5/8" LEOPOLDVILLE Aut. Vh  
PROPOSED ALTERATION ON BILGES No 18753  
IN NO 1 MAZOUT OR PALM OIL TANK

*Suggest amendments  
on this copy  
B.V.N.*

1<sup>ST</sup> PROPOSITION  
INDEPENDENT DRY BILGES

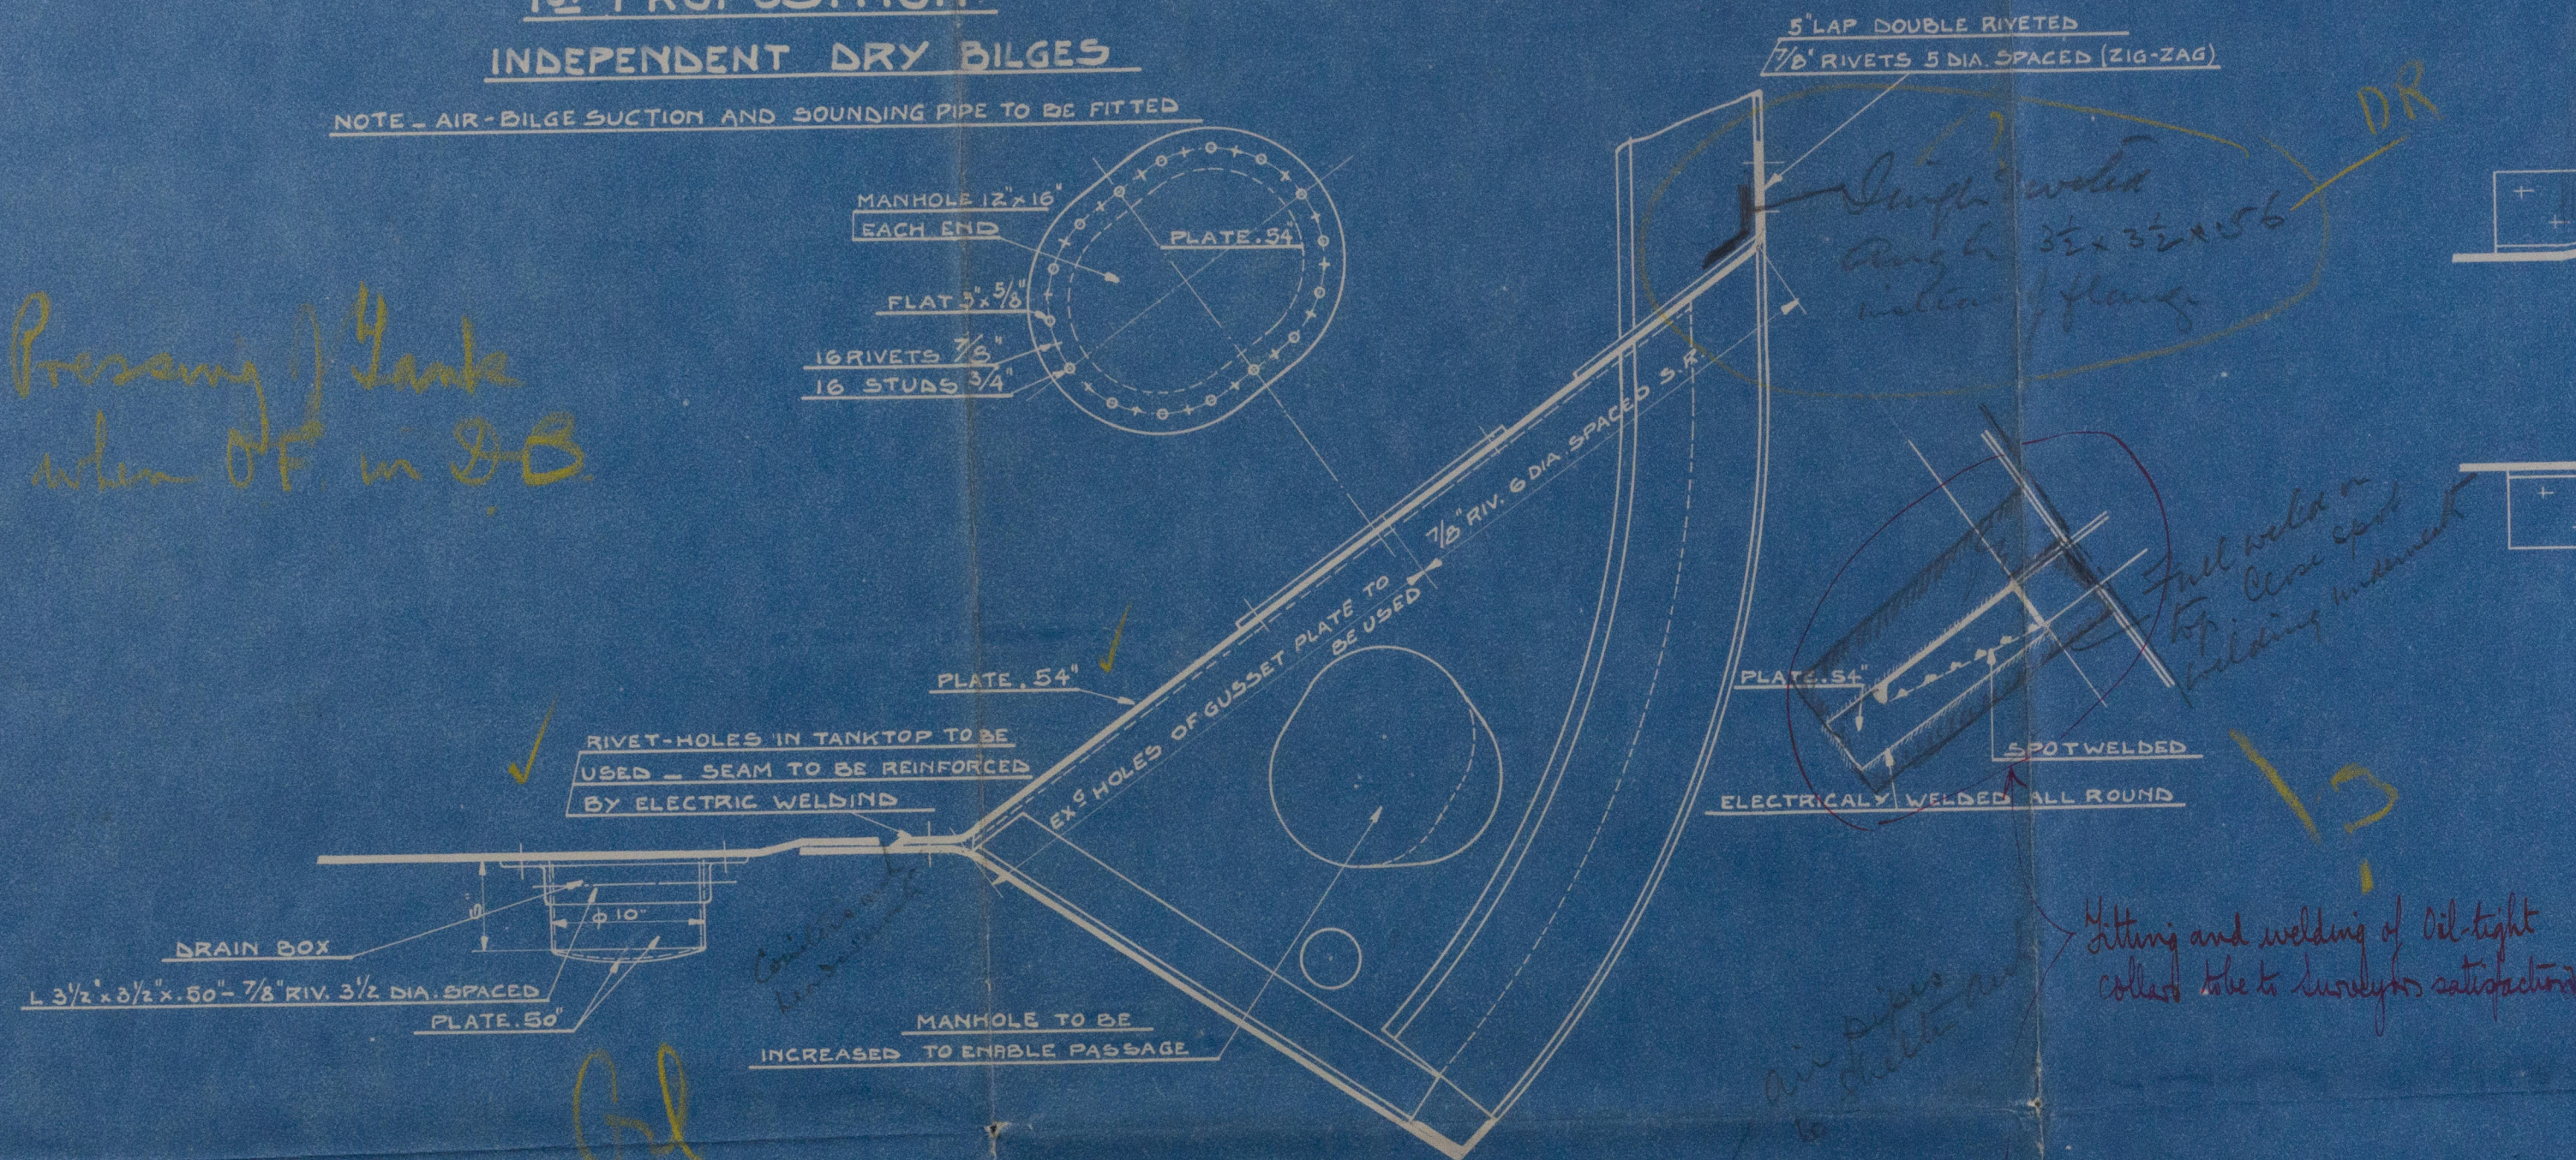
*Preserving Tank  
when OF in D.B.*

2<sup>ND</sup> PROPOSITION - DOUBLE BOTTOM EXTENDED

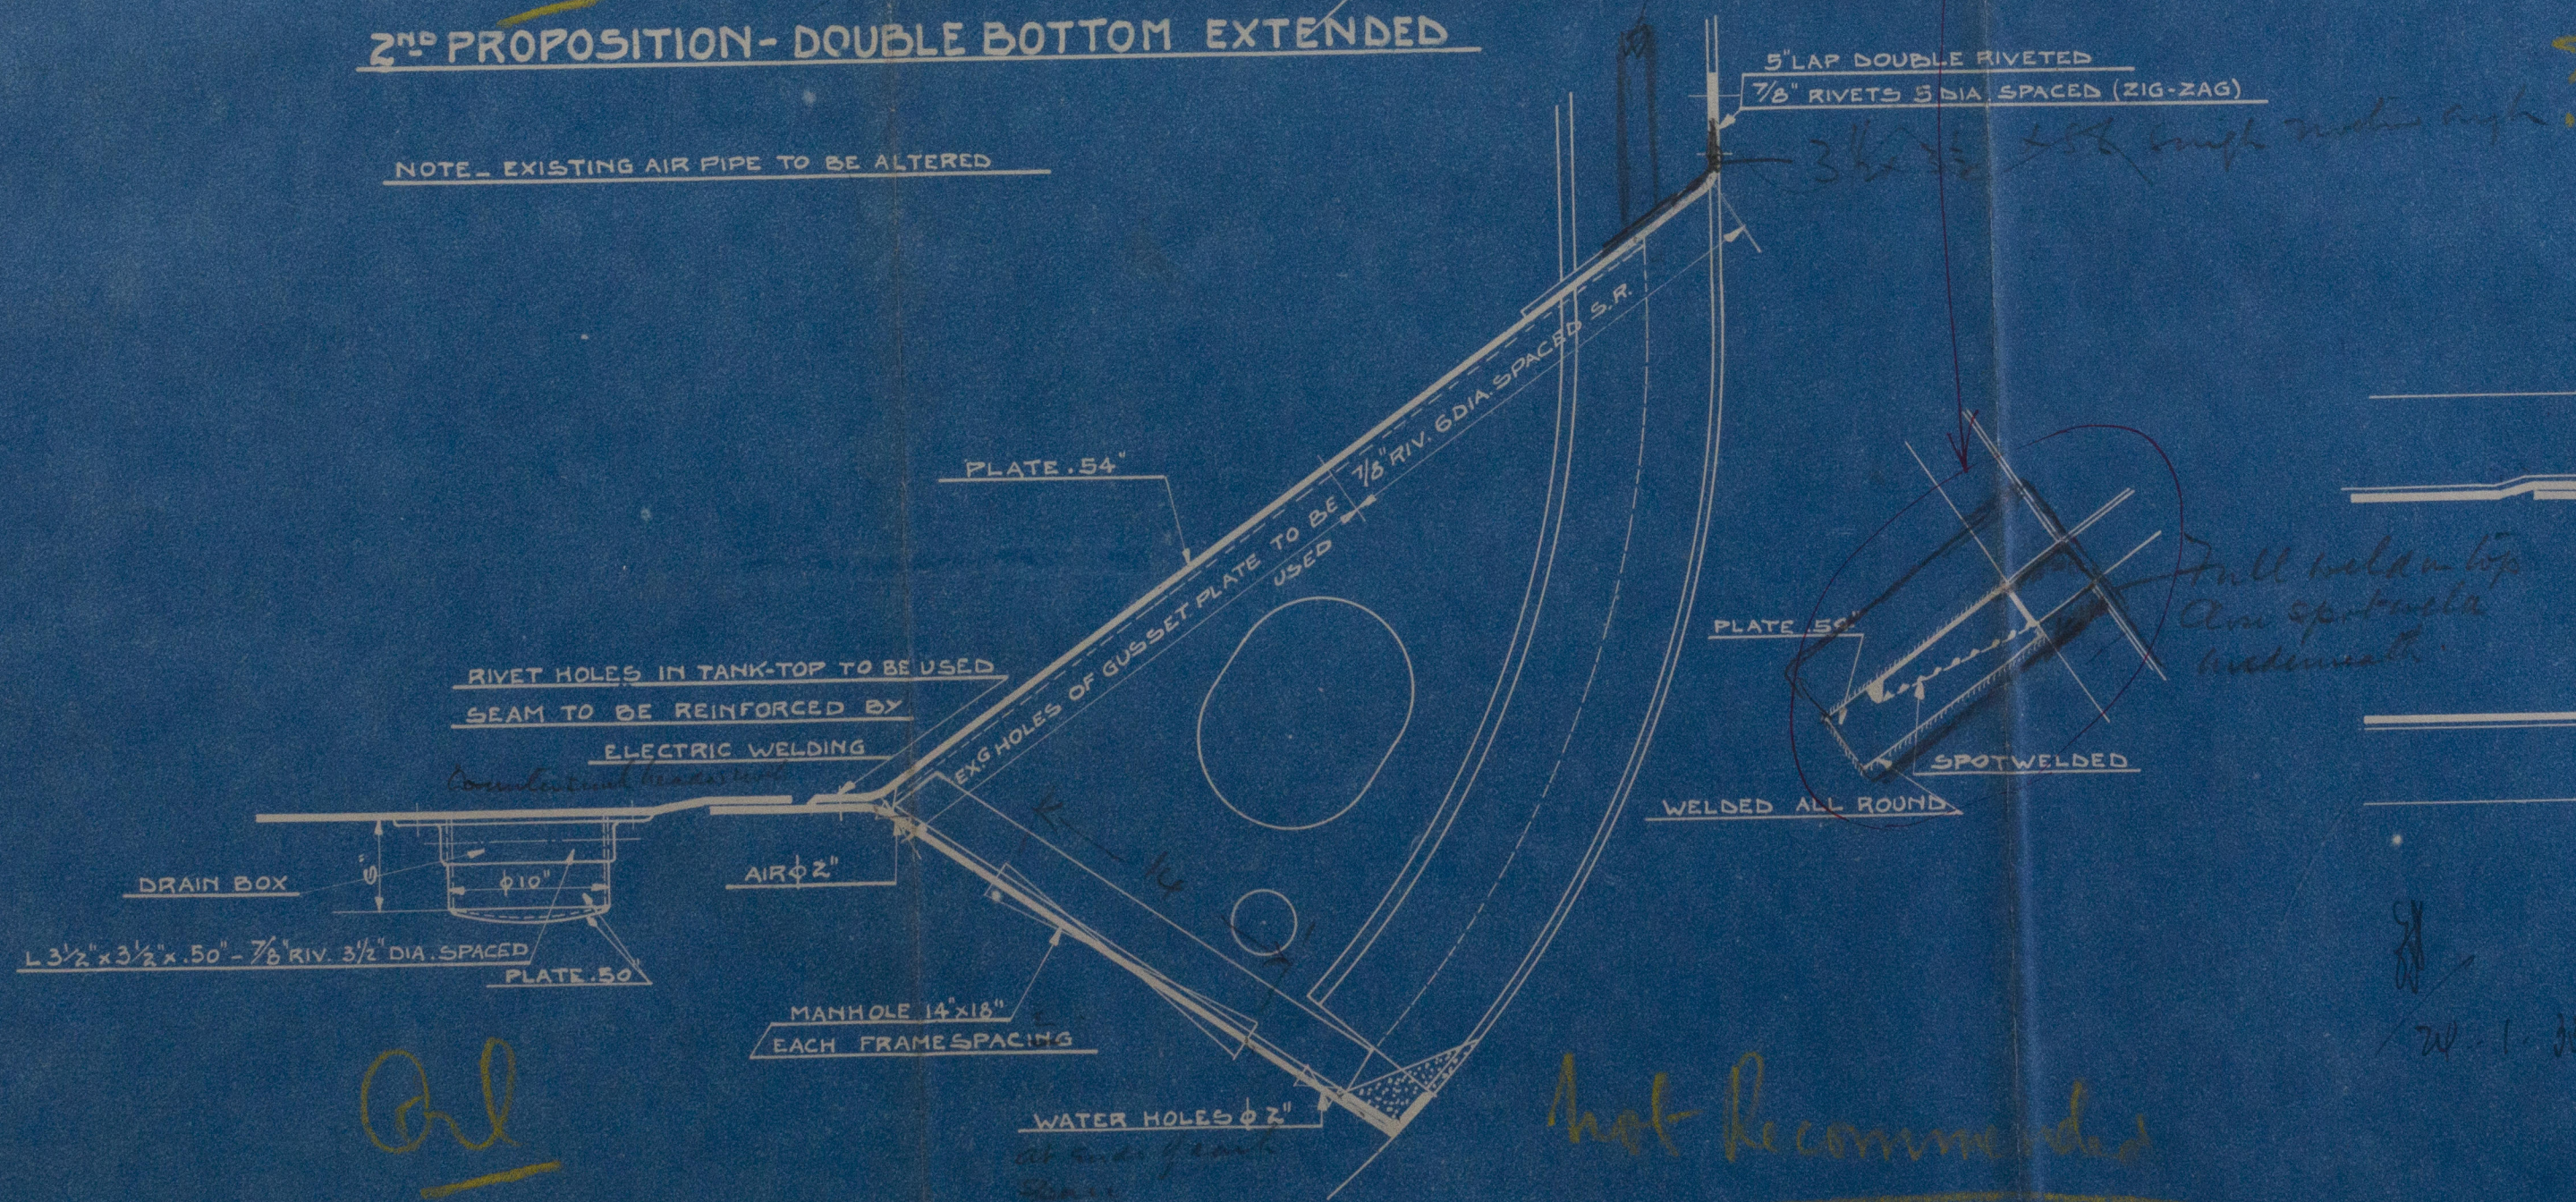
*Not Recommended*
